### Safe, Clean Water Program Scoring Committee Meeting Minutes

Tuesday October 5, 2021 1:00 PM – 4:00 PM WebEx Meeting

## Safe, Clean Water Program Scoring Rubric - Fiscal Year 2022-2023

Safe Clean Water Projects Module Jackson ES, Revised FS

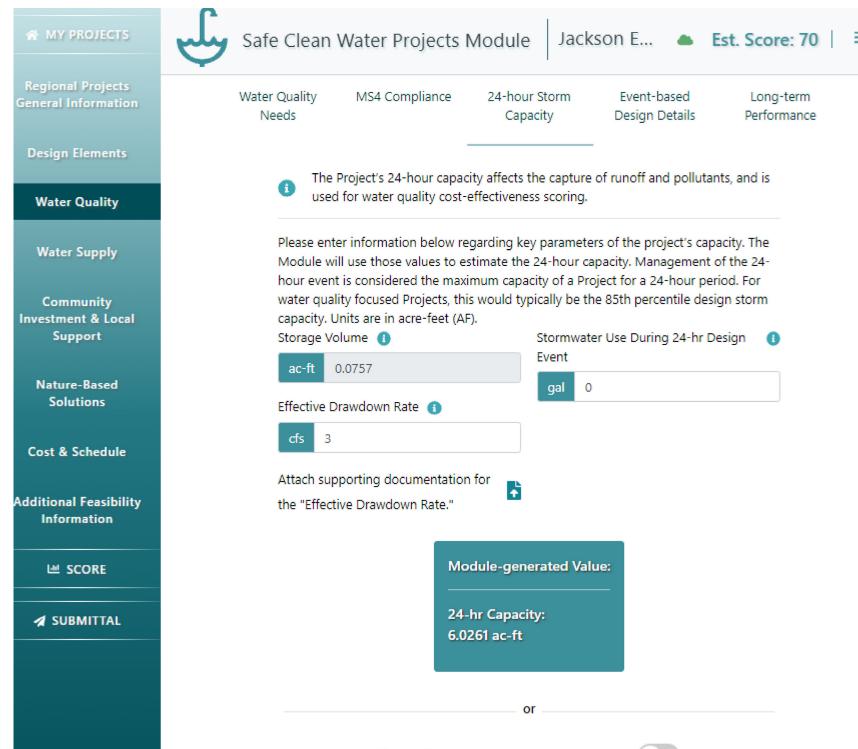
1. When entering parameters into the Module, the determination of infiltration well units (Section 2.1 Configuration) and stormwater use during 24-hour design event (Section 3.3 24-hour Storm Capacity) were incorrect. Based on the storage volume in each drywell, total infiltration well units should be 4.21, resulting in a storage capacity of 0.0757 acre-feet. An effective drawdown rate of 3.0cfs (0.3cfs/well x 10 wells), and 0.0 gallons of use during the event, results in a 6.03 acre-feet 24-hour BMP capacity.

2. Two numbers were transposed in Table 2 of the "Hydrology and Water Quality Analysis" as part of Attachments for Section 2.4. The total inflow volume during design event, which is entered into Section 3.4 of the Module, should be 2.0 acre-feet. Likewise, the peak inflow rate during design event should be 4.4cfs.

Attached are screenshots from the Module with the above corrections. With no change to the layout, design or modeling, applicant scoring remains the same at 70.
